EARLY DESIGN GUIDANCE 4

This document is the fourth in a series of City of Seattle Early Design Guidance (EDG) submittals made in reference to a proposed arena to be located within the 'Stadium District'. Building upon the analysis, synthesis, and design direction established in the first three EDG submittals, the general intent of this document is to respond to specific recommendations and comments made by the Design Review Board during the EDG 3 review meeting.

SEATTLE ARENA FEBRUARY 22, 2013

SPECIFIC PROJECT ISSUE #3: REMOVAL OF EXISTING PARKING LANE ALONG 1ST AVENUE

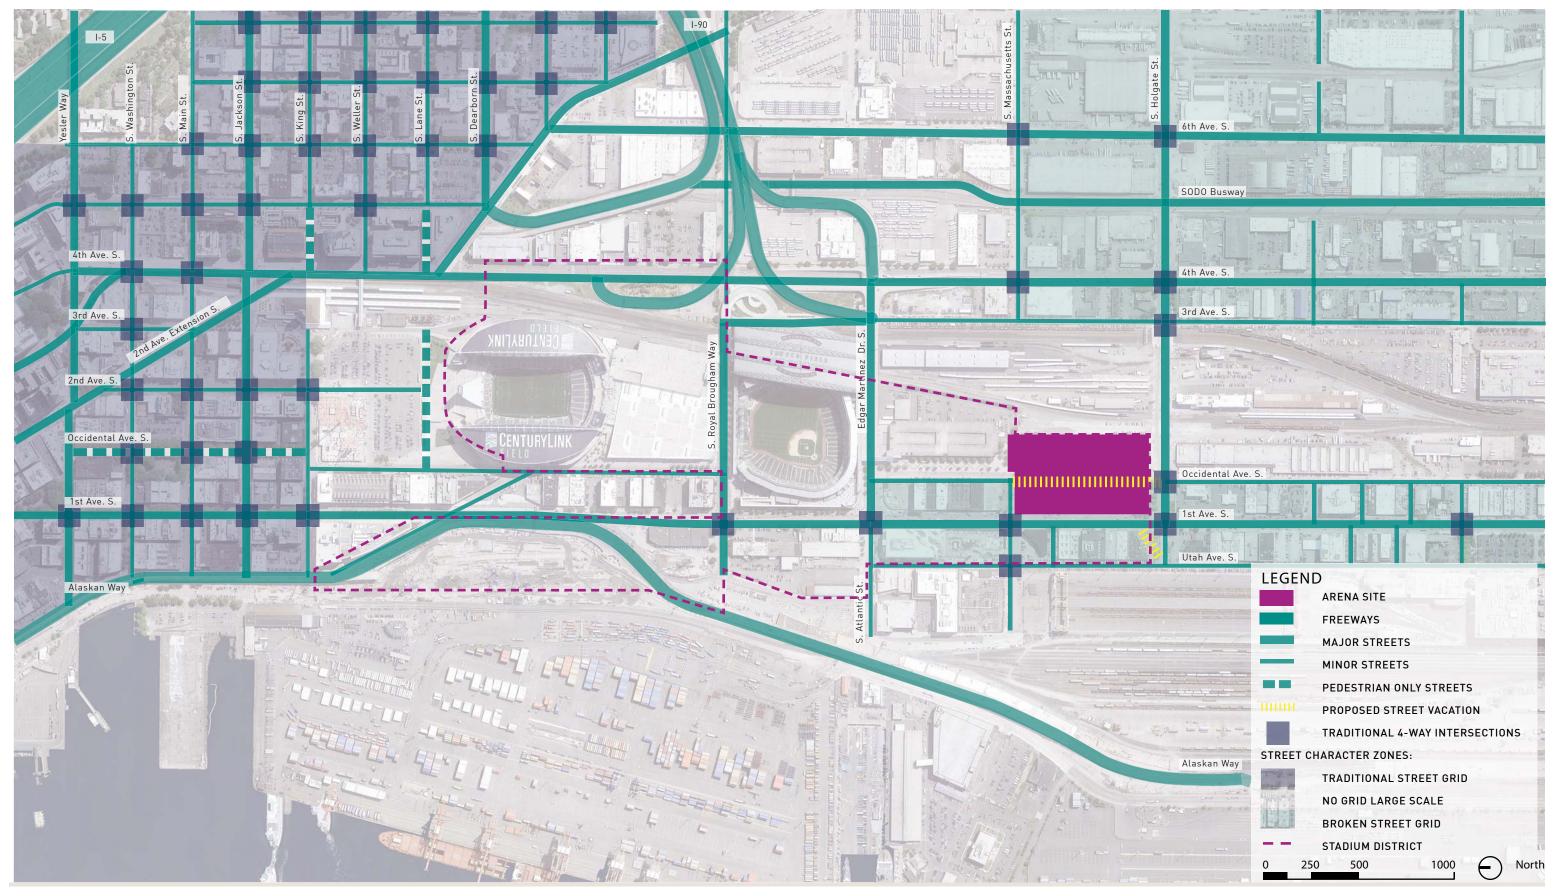
DRB COMMENT:

SDOT HAS NOT APPROVED REMOVAL OF THIS LANE AND SUCH APPROVAL IS UNLIKELY GIVEN THE TRAFFIC CAPACITY AND POSSIBLE STREETCAR SPACE NEEDS IN THE ROW. ADDITIONALLY, THERE IS THE NEED FOR CURBSIDE ADA, SHUTTLE BUS DROP-OFFS AND OTHER TRANSPORT-TO-ENTRANCE ADJACENCIES. THE BOARD ADVISED THAT A WIDENED SIDEWALK (ABOUT 20 FT PAVED PEDESTRIAN WIDTH, PLUS A CURBSIDE BUFFER) BE CREATED VIA A CONTINUOUS BUILDING SETBACK, TO ACCOMMODATE THE EVENT GENERATED PEDESTRIAN FLOWS. (FOR REFERENCE, NOTE THE EXISTING SAFECO FIELD 1ST AVENUE SIDEWALK IS ABOUT 30 FT. WIDE)

360 RESPONSE:

- 1. HAVE FOCUSED CURRENT DESIGN ON RETAINING EXISTING CURB LINE. WE ARE CONTINUING TO HOLD AN ADDITIONAL OPTION WHICH SHOWS THE REMOVAL OF THE EXISTING PARKING LANE.
- 2. CURRENT DESIGN RECESSES BUILDING 8 FT. FROM PROPERTY LINE FOR THE ENTIRE LENGTH ALONG 1ST AVENUE TO WIDEN SIDEWALK FOR PEDESTRIAN FLOW WITHOUT TAKING PARKING LANE.

SPECIFIC PROJECT ISSUE #5: HOLGATE USES AND LOADING

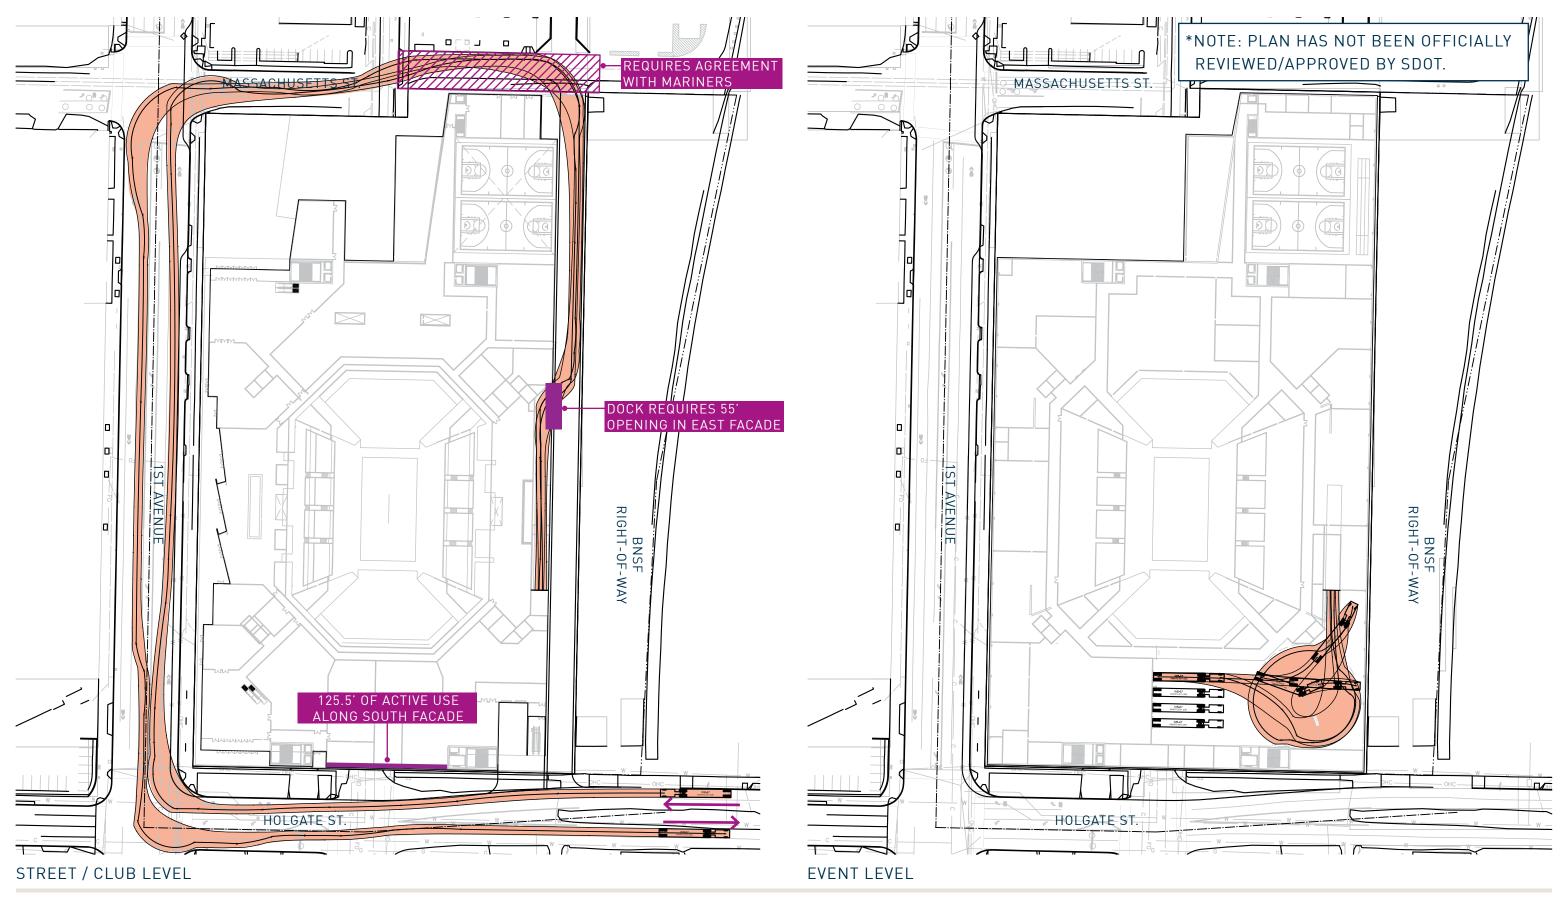
DRB COMMENT:

THE PROPOSED LOCKER AND OFFICE USES ARE NOT IDEAL ACTIVATOR USES ALONG A SIDEWALK; AND TRUE ACTIVE USES SHOULD EXTEND FURTHER EAST ON THE HOLGATE FRONTAGE. THE HOLGATE LOADING RAMP PARALLEL AND ADJACENT TO THE PROPERTY LINE CREATES A BLANK WALL, AND THE PROPOSED GREEN WALL IS TOO LARGE FOR AN AT-GRADE, PEDESTRIAN LOCATION. THE PROPOSED ACCESS ROAD, LOADING AND RAMPS IMPACT THE SIDEWALK GREATLY; ALL THOSE FUNCTIONS SHOULD BE FULLY INTERNALIZED ON THIS EXCEPTIONALLY LARGE (6.3 ACRE) SITE. TO CORRECT THIS SITUATION, THE BOARD'S SUGGESTIONS IN OFF SITE ITEM #5 ABOVE SHOULD BE STRONGLY PURSUED. THE SOUTHWEST ENTRANCE SHOULD BE RECESSED MORE FROM THE BUSY INTERSECTION FOR PATRON QUEUING AND SECURITY CHECKS, SIMILAR TO HOW THE NORTHWEST ENTRY FUNCTIONS.

360 RESPONSE:

- 1. LOADING DOCK OPTIONS FROM BOTH NORTH AND SOUTH APPROACHES HAVE BEEN ADJUSTED TO INCREASE ACTIVATION ALONG HOLGATE.
- 2. CURRENT TRASH AND FOOD SERVICE DOCK OPTIONS INCLUDE LOADING OFF HOLGATE AS WELL AS LOADING FROM ACCESS ROAD. LOADING FROM THE ACCESS ROAD DECREASES THE VISIBILITY OF THE DOCK FROM HOLGATE ST.

FIN WALL/SIGNAGE

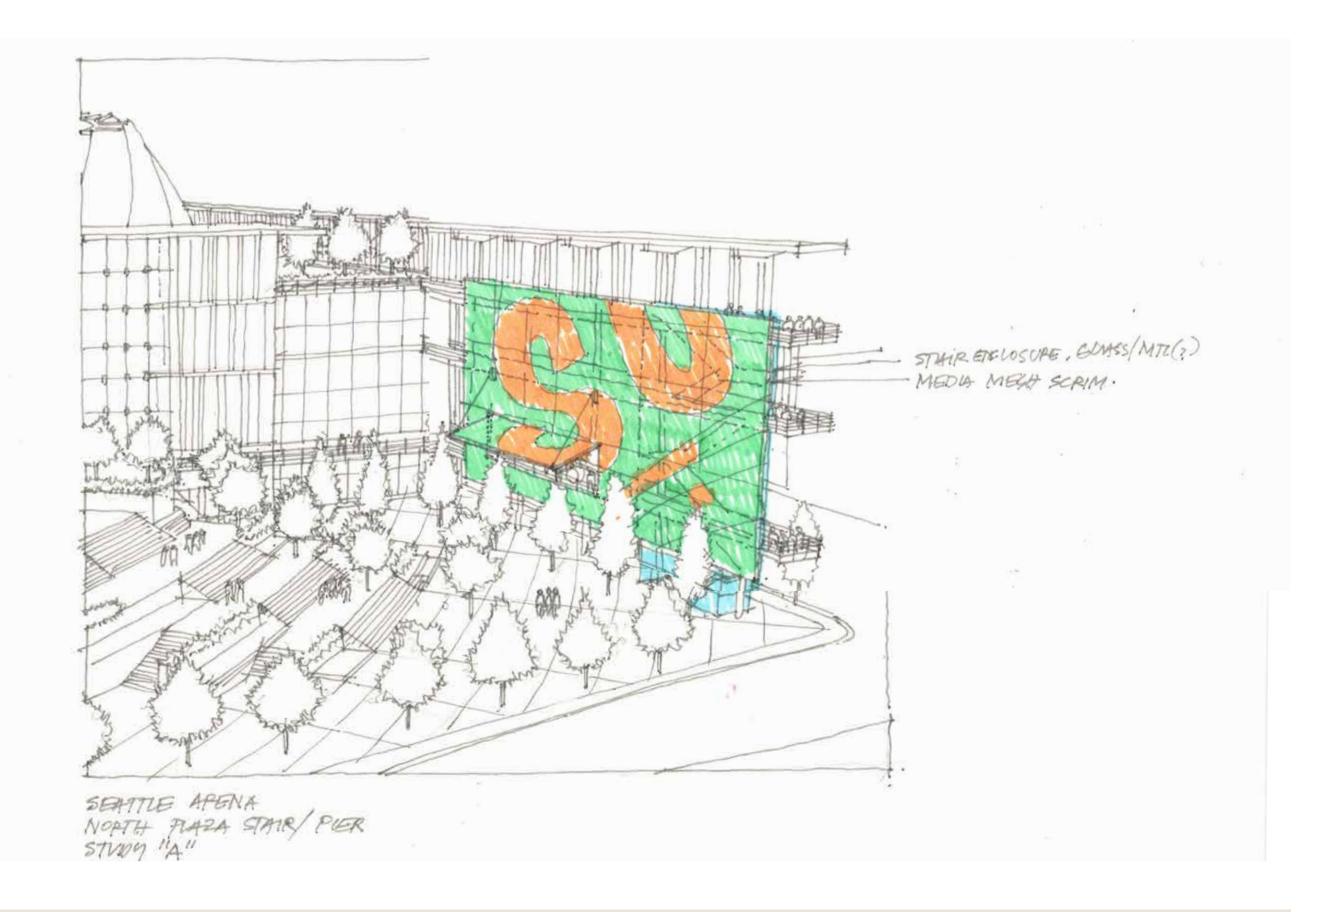
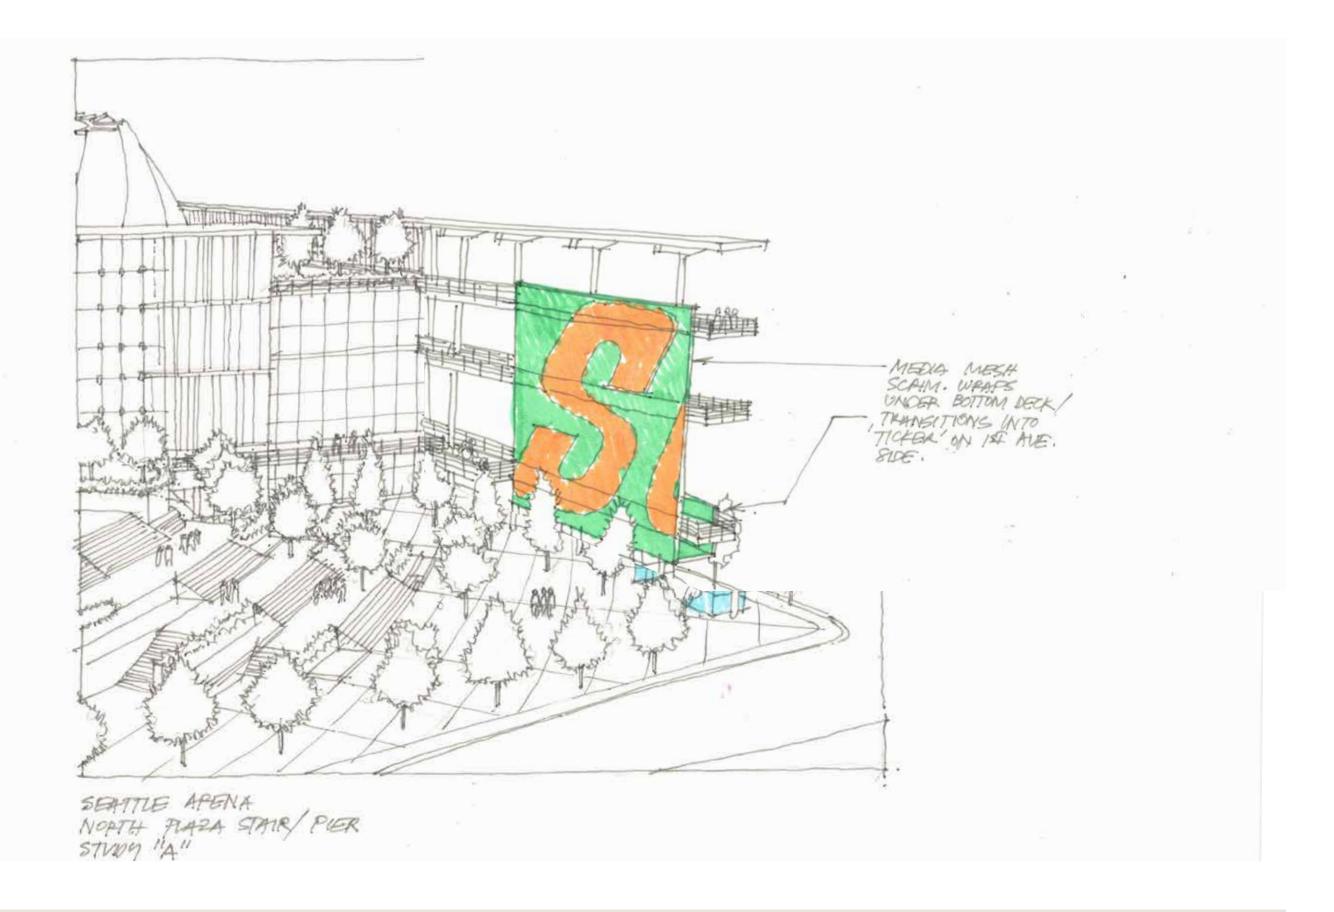
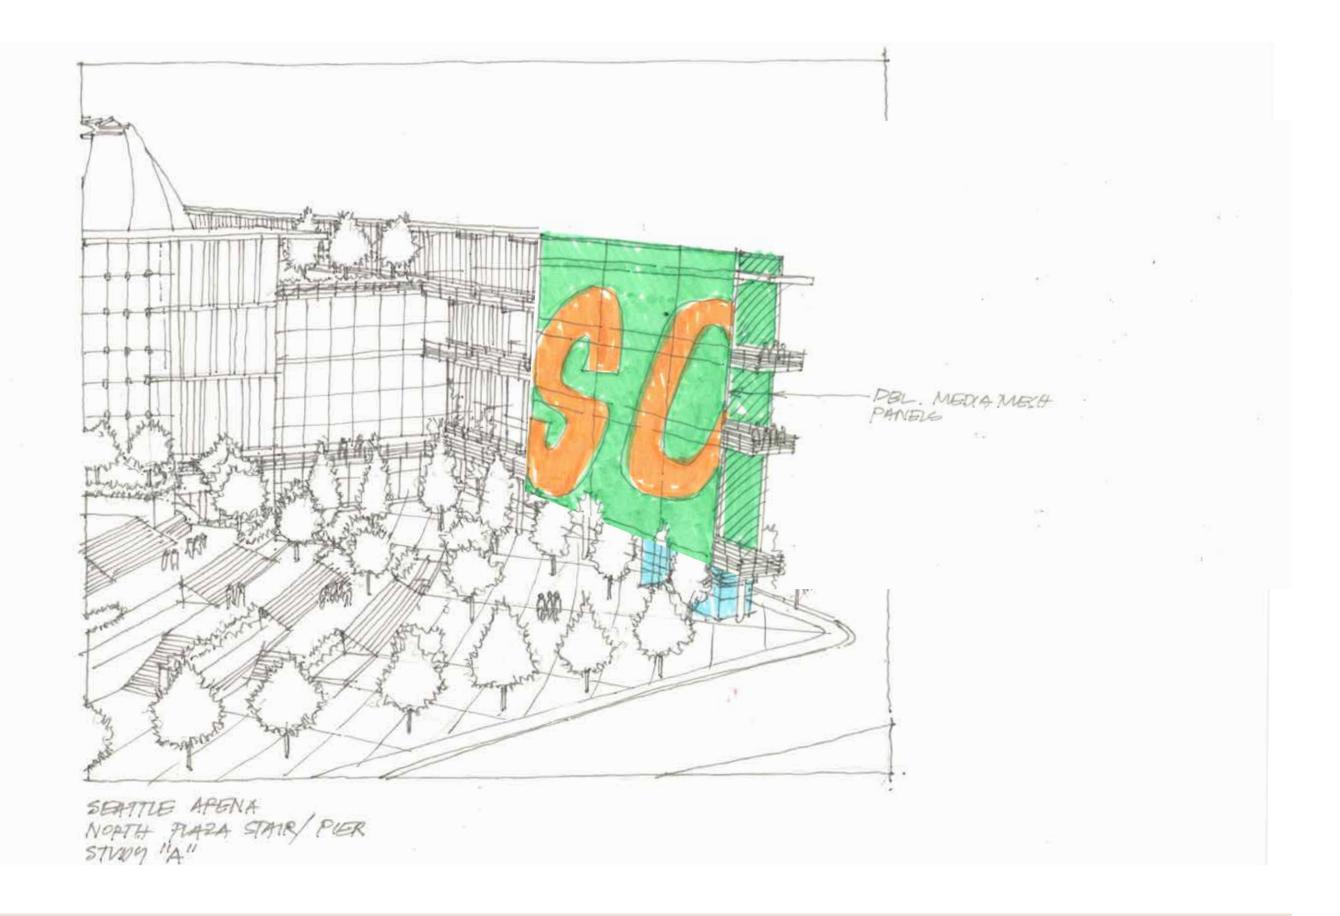
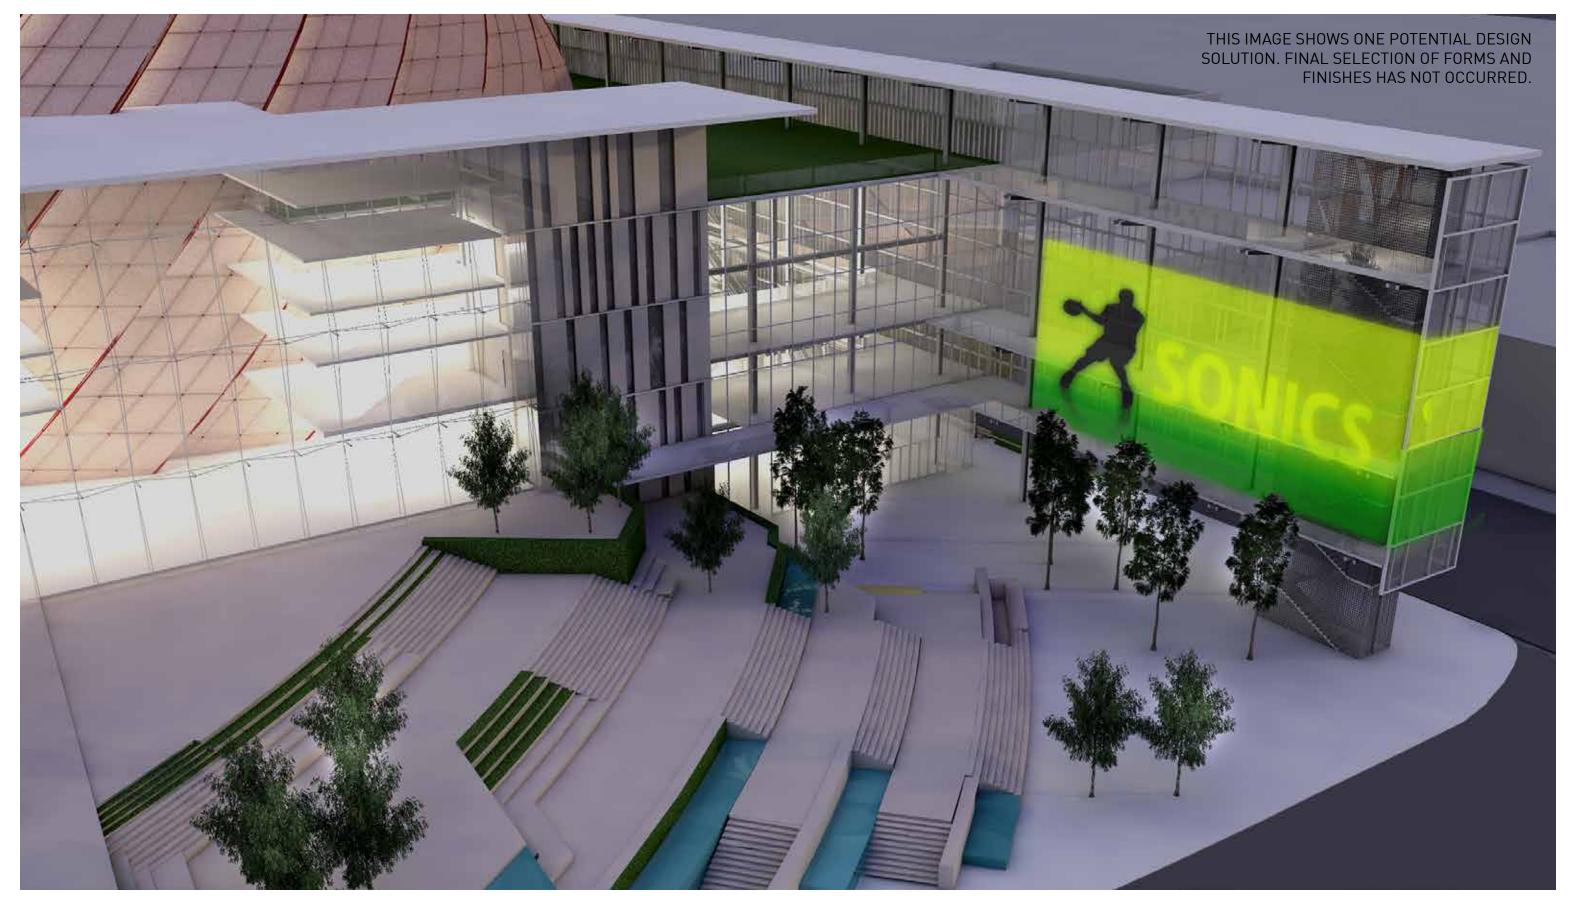
PROJECT SPECIFIC ISSUE #2: SIGNAGE/FIN-WALL ALONG FIRST AVENUE

DRB COMMENT: THE BOARD IS CONCERNED THE FIN BLOCKS VALUABLE WINTER SOUTHWEST SUN FROM THE ADJACENT PUBLIC

PLAZAS, AND REQUESTED ACCURATE SHADOW STUDIES. QUESTIONED THE ESSENTIAL PURPOSE OF SUCH AN ELEMENT, BESIDES SIGNAGE? THIS NEW FIN ELEMENT MUST BE SHOWN ON THE GROUND FLOOR/PLAZA PLANS,

INCLUDING ANY CODE REQUIRED STAIRS/EXITING, AND NEEDS MORE BOARD EVALUATION.

360 RESPONSE: 1. CREATES AN OUTDOOR ROOM

2. PORTAL INTO THE PLAZA

3. CREATES A BACKDROP FOR ENTERTAINMENT
